Draft **EN 300 403-1** V1.3.1 (1999-07)

**Integrated Services Digital Network (ISDN);
Digital Subscriber Signalling System No. one (DSS1) protocol;
Signalling network layer for circuit-mode basic call control;
Part 1: Protocol specification**

[ITU-T Recommendation Q.931 (1993), modified]

Figure 4-8: Information element format using escape for extension

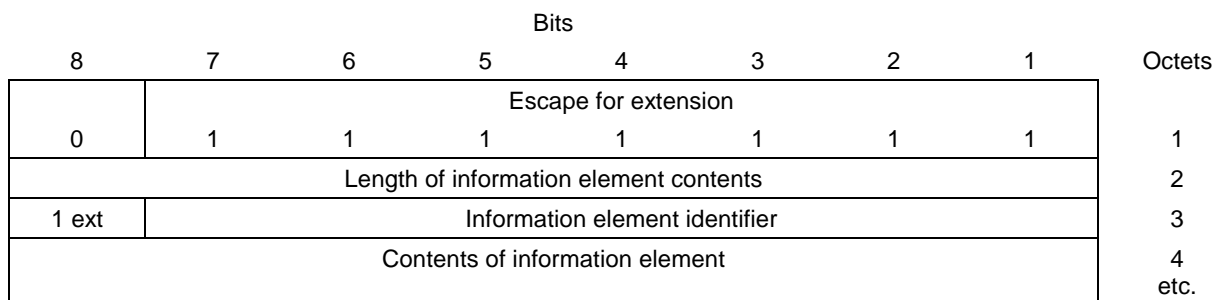
1 1 1 0 0 0 0	Called party number	4.5.8	23
1 1 1 0 0 0 1	Called party subaddress	4.5.9	23
1 1 1 1 0 0 0	Transit network selection (note 2)	4.5.29	(note 4)
1 1 1 1 0 0 1	Restart indicator	4.5.25	3
1 1 1 1 1 0 0	Low layer compatibility	4.5.19	18
1 1 1 1 1 0 1	High layer compatibility (note 2)	4.5.17	5
1 1 1 1 1 1 1	Escape for extension (note 3)		
All other values are reserved (note 5).			
NOTE 1: The length limits described for the variable length information elements below take into account only the present ITU-T standardized coding values. Future enhancements and expansions to the present document will not be restricted to these limits.			
NOTE 2: This information element may be repeated.			
NOTE 3: This escape mechanism is limited to codesets 5, 6 and 7 (see subclause 4.5.2). When the escape for extension is used, the information element identifier is contained in octet group 3 and the content of the information element follows in the subsequent octets as shown in figure 4-8.

Figure H.5 (sheet 1 of 5): Message reassembler SDL

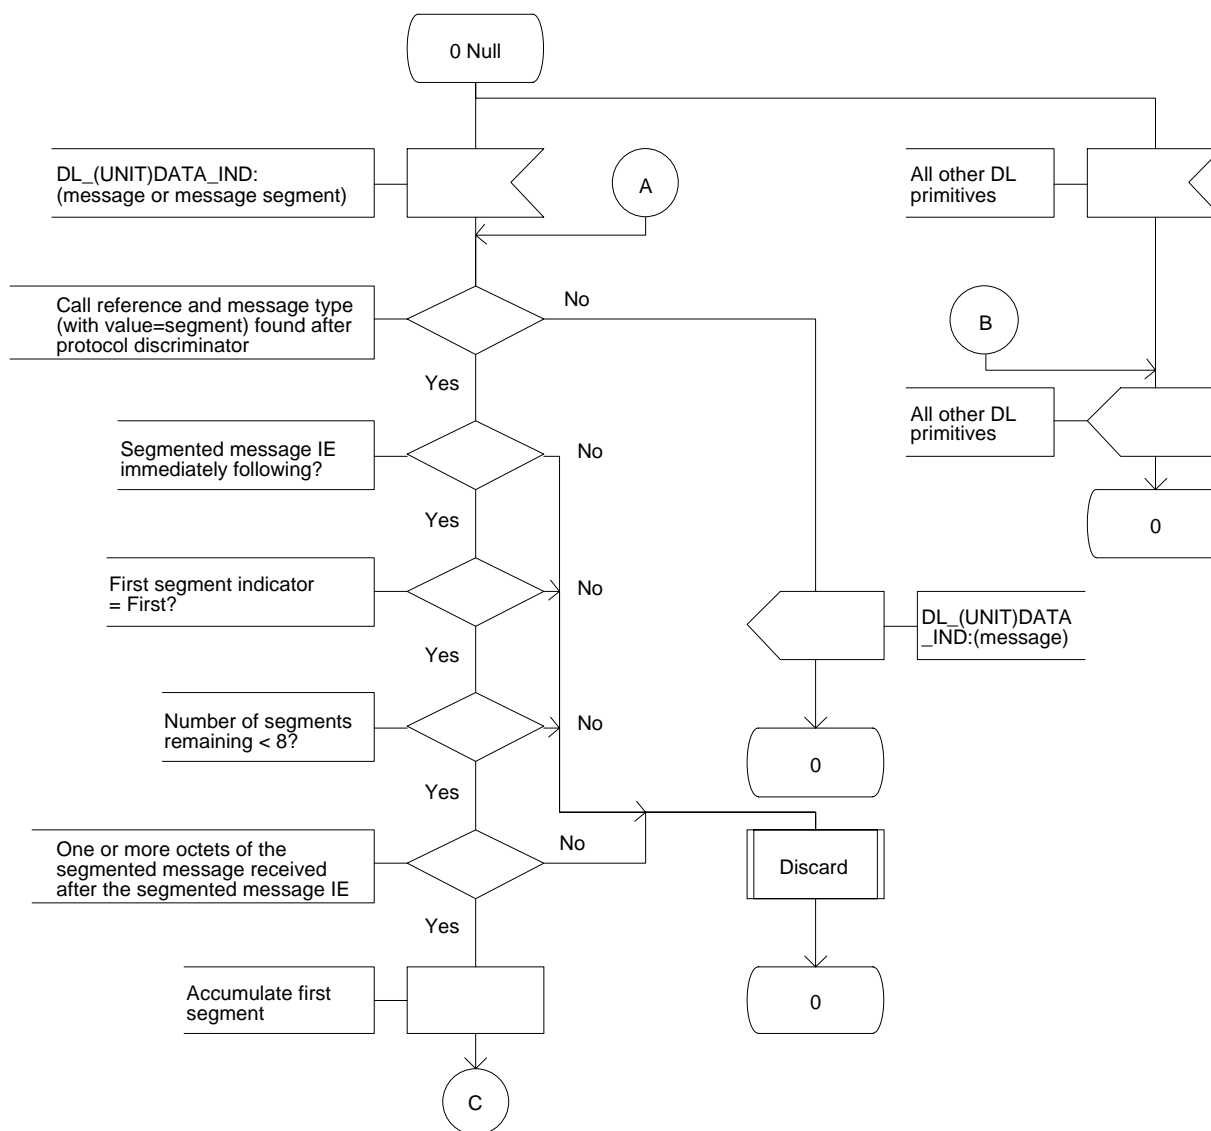
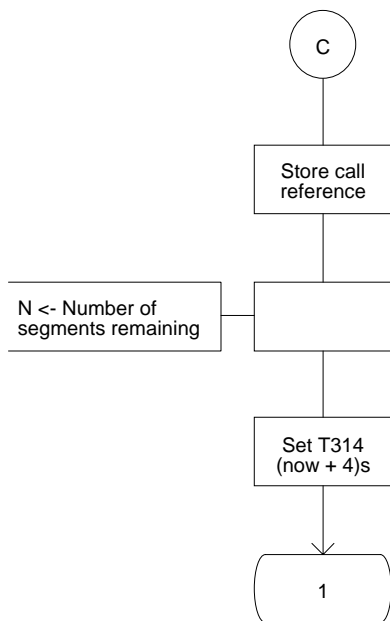
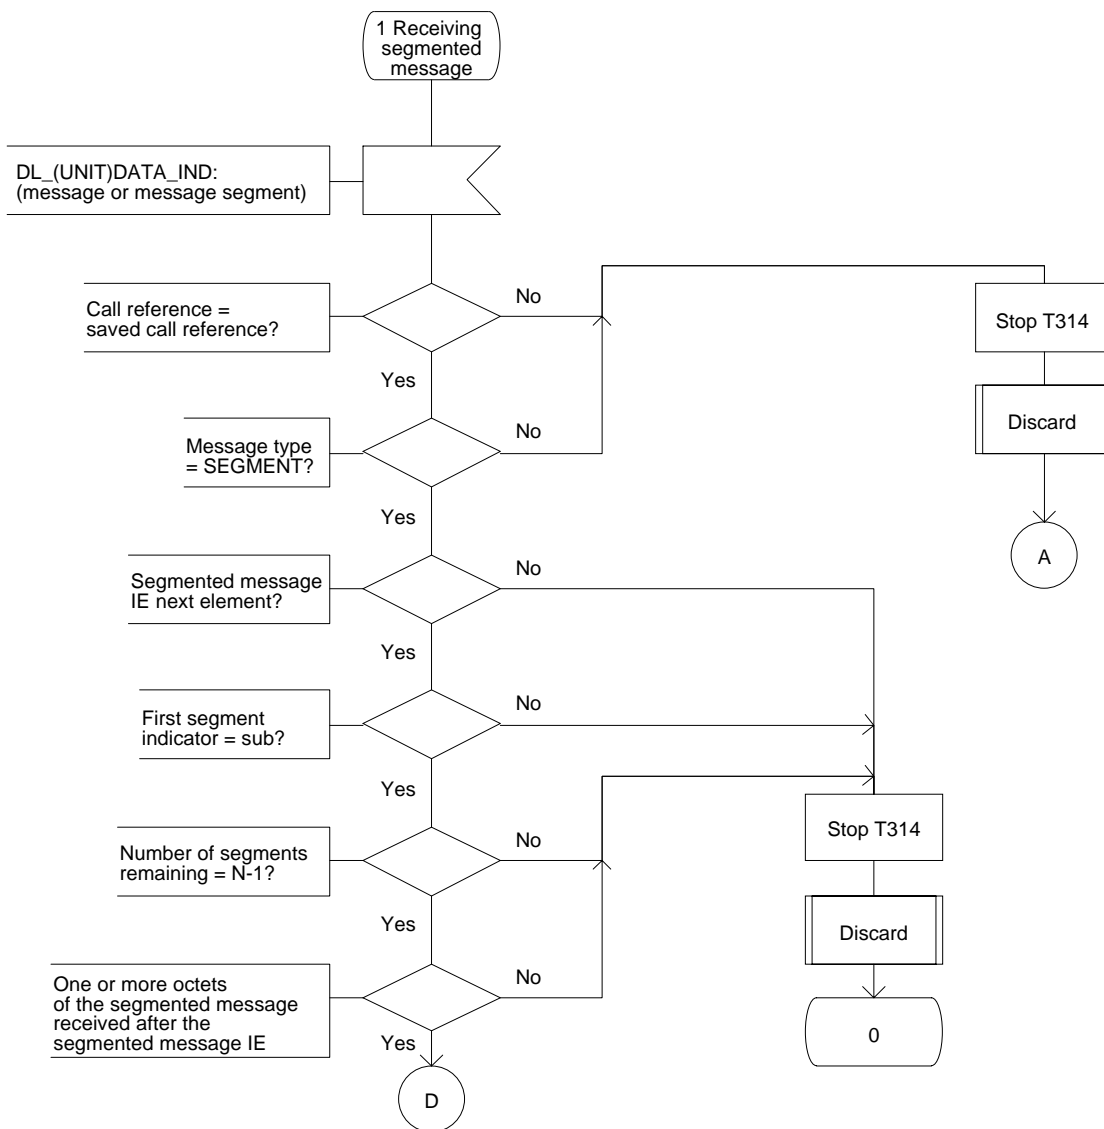
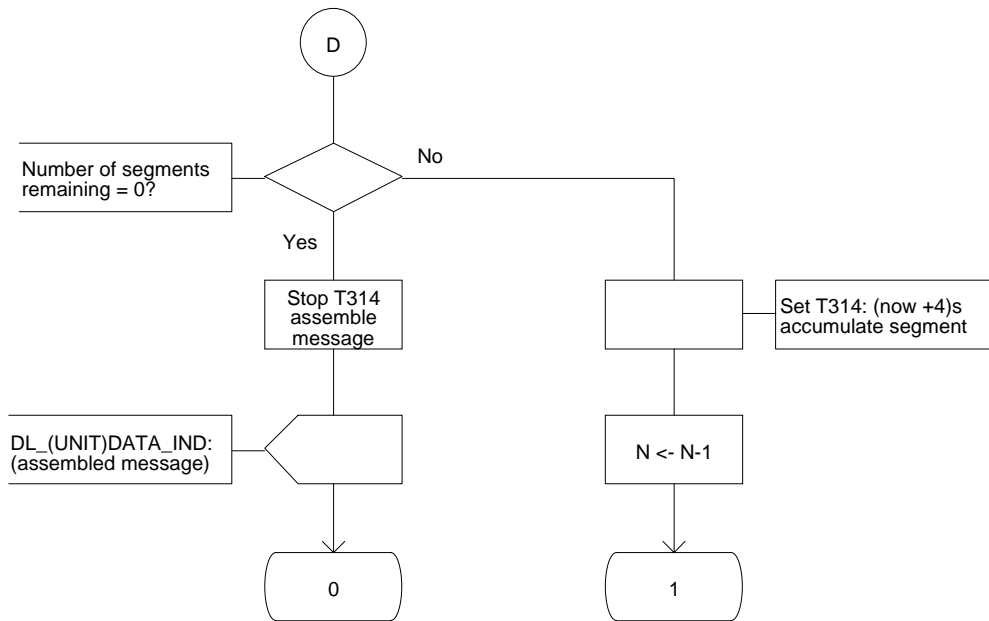
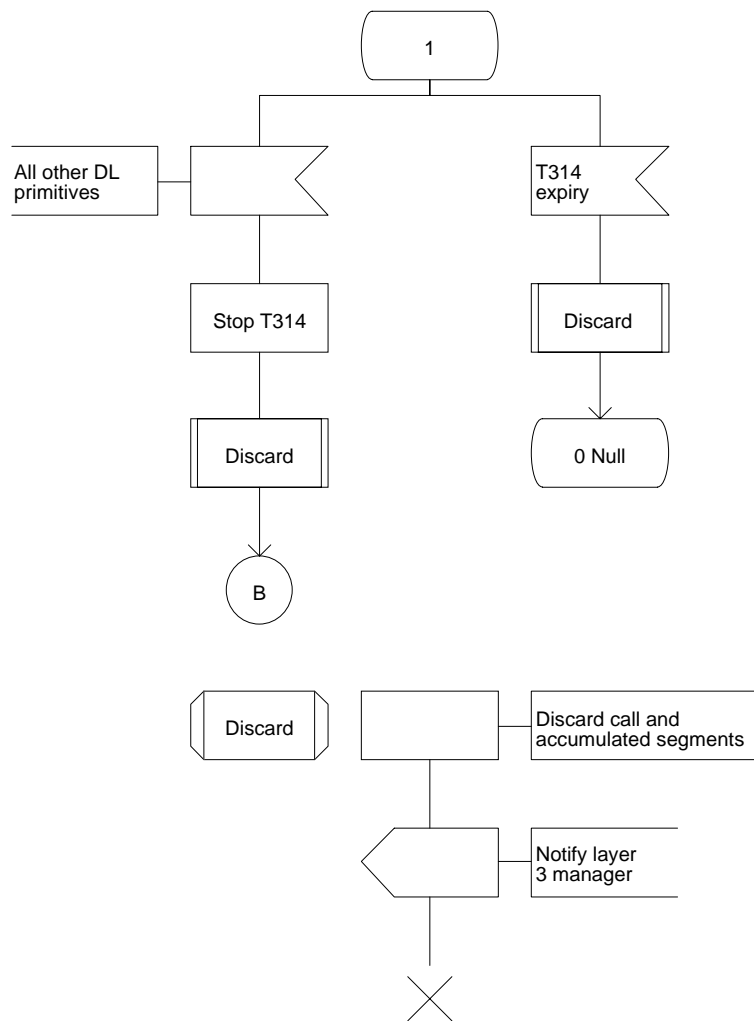
Pages 275 to 277, figure H.5/Q.931 (3 sheets)

Replace figure H.5/Q.931 (3 sheets) by the following figure (5 sheets):
